**ADDENDUM 1
RFB 18-0011
MURDOCK TAG REMODEL**

SEDGWICK COUNTY OMD REMODEL

Prepared by:
Schaefer Johnson Cox Frey Architecture, Inc.

1 ROOF PLAN
3/16" = 1'-0"

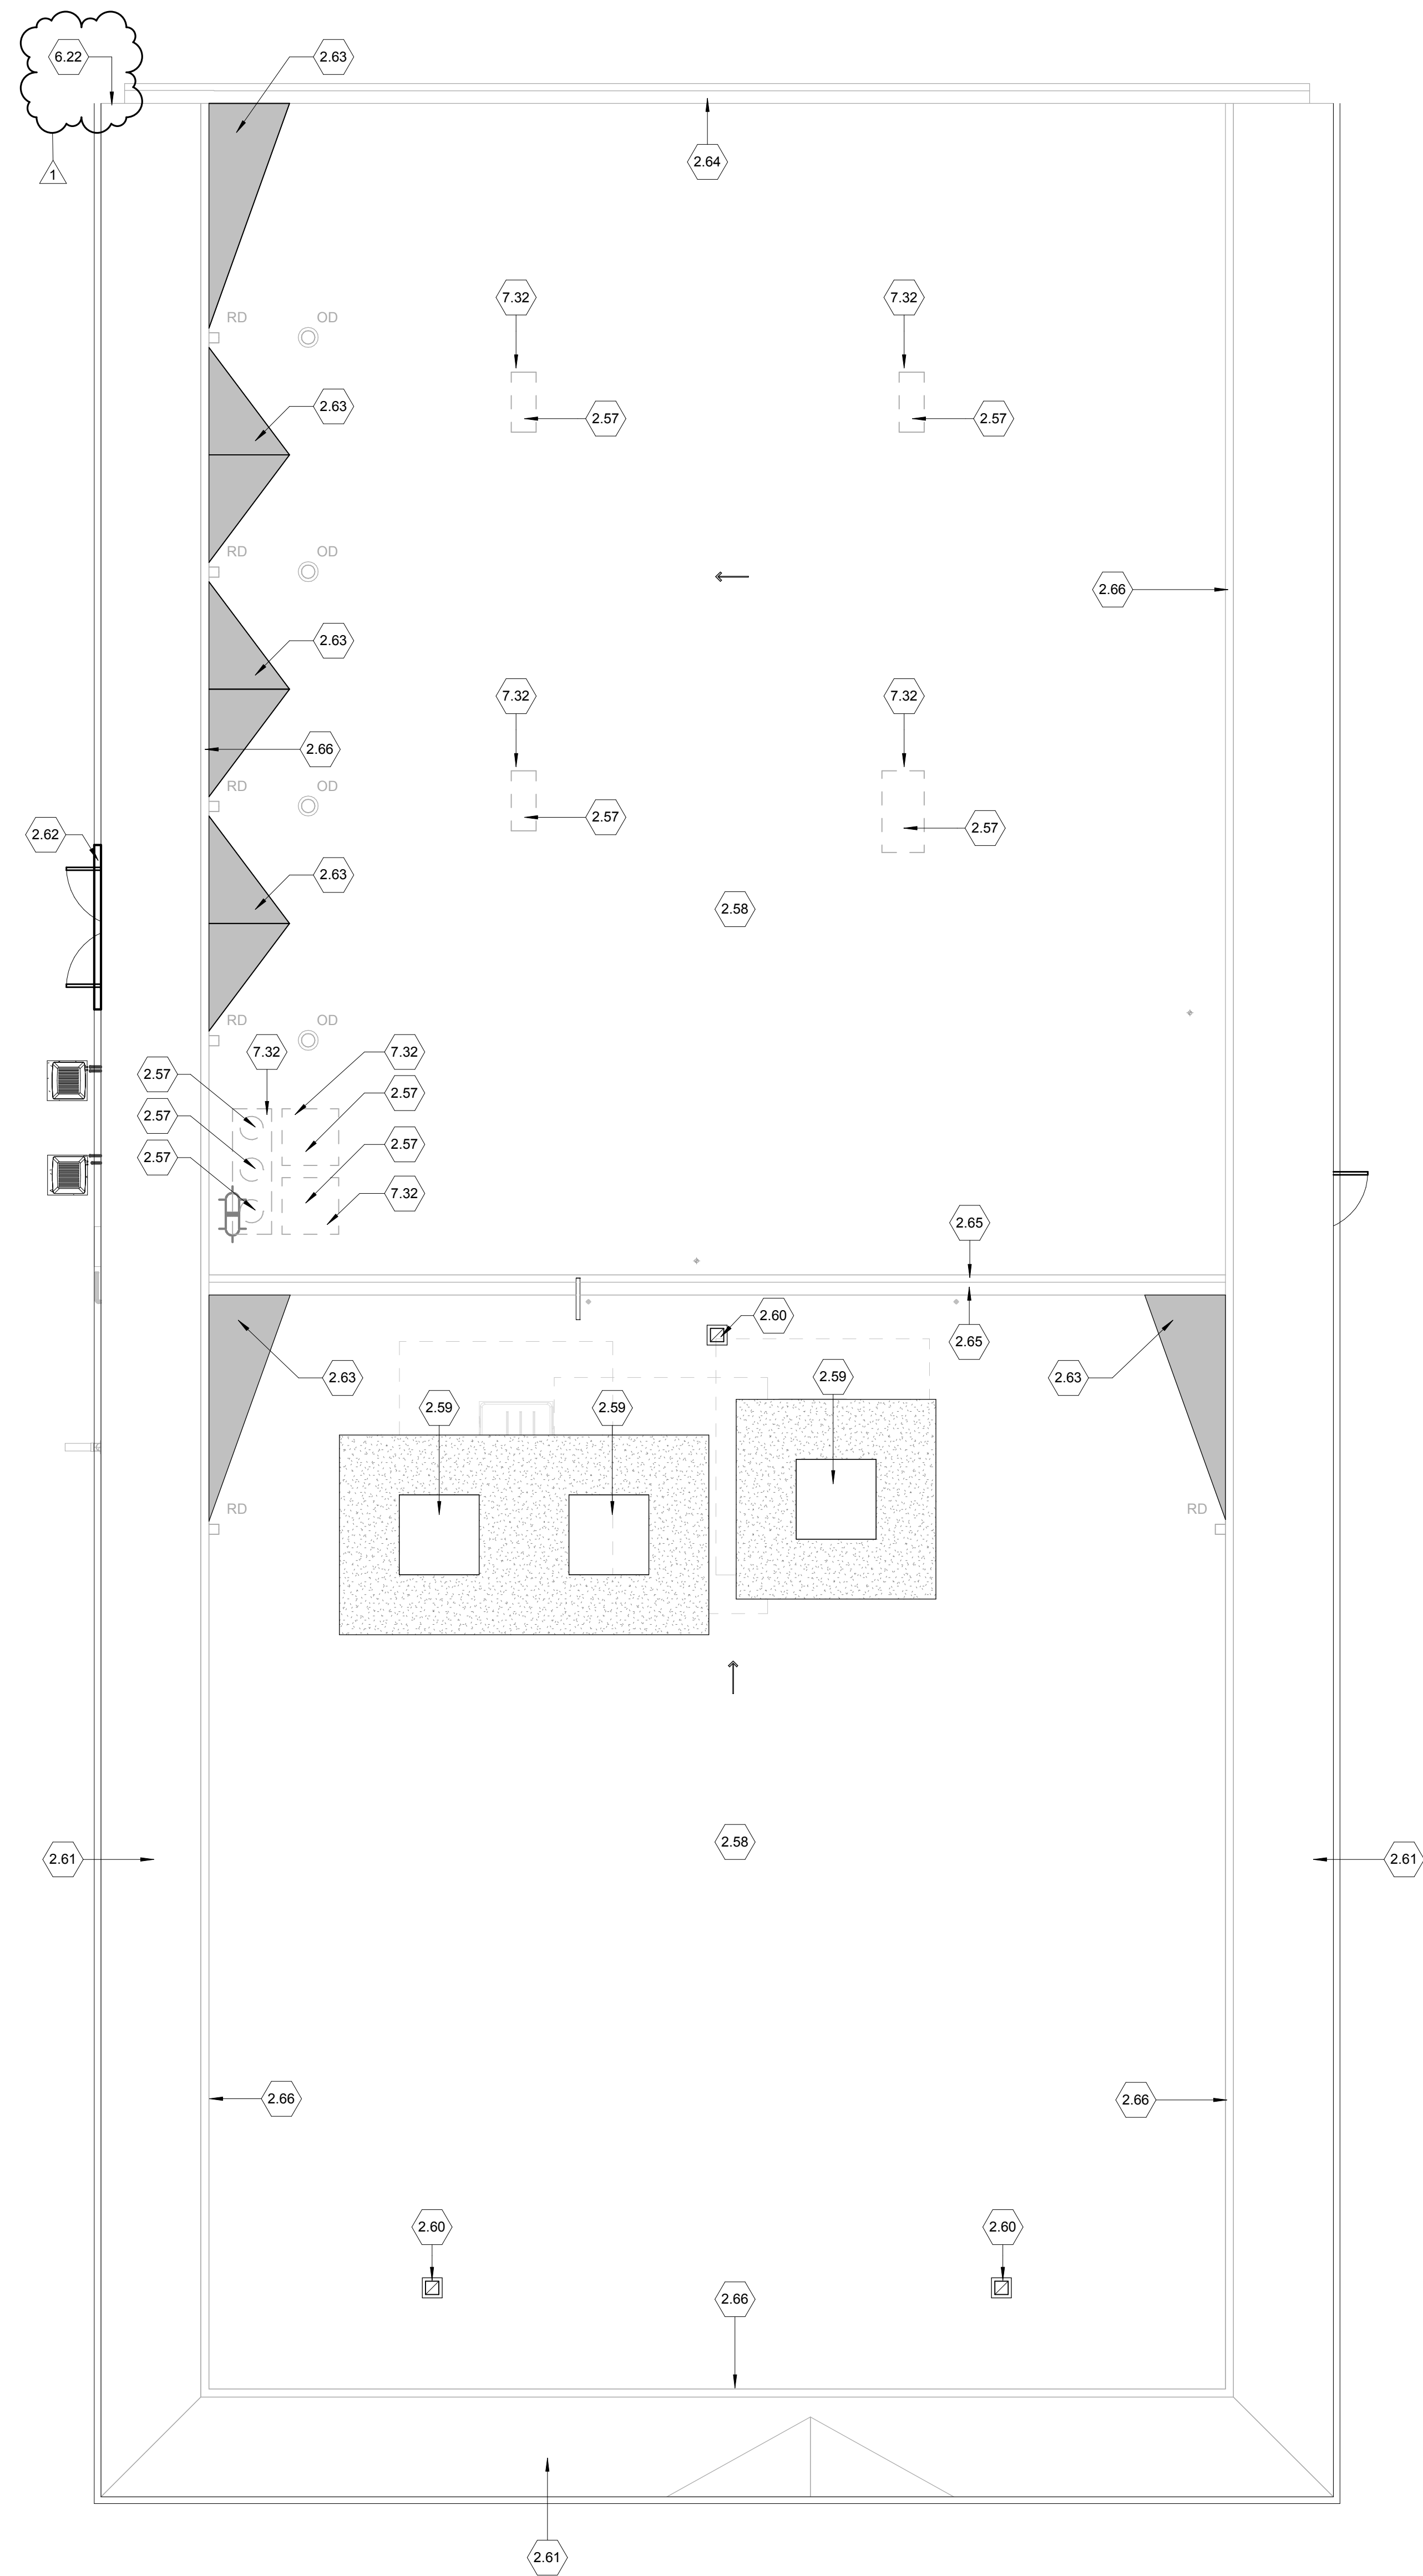
DRAWING SHEET A24.1:

Replace drawing sheet A24.1 with attached drawing sheet A24.1R including replacement of rotted trim at north end of mansard on west side of building.

- 2.65 REPLACE ROTTED TRIM AT NORTH END OF MANSARD WITH NEW PAINTED WOOD TRIM.
- 6.22 PAINT HOLES IN ROOF AFTER MECHANICAL EQUIPMENT IS REMOVED PRIOR TO APPLYING NEW ROOF. USING NEW INSULATION AS REQUIRED.
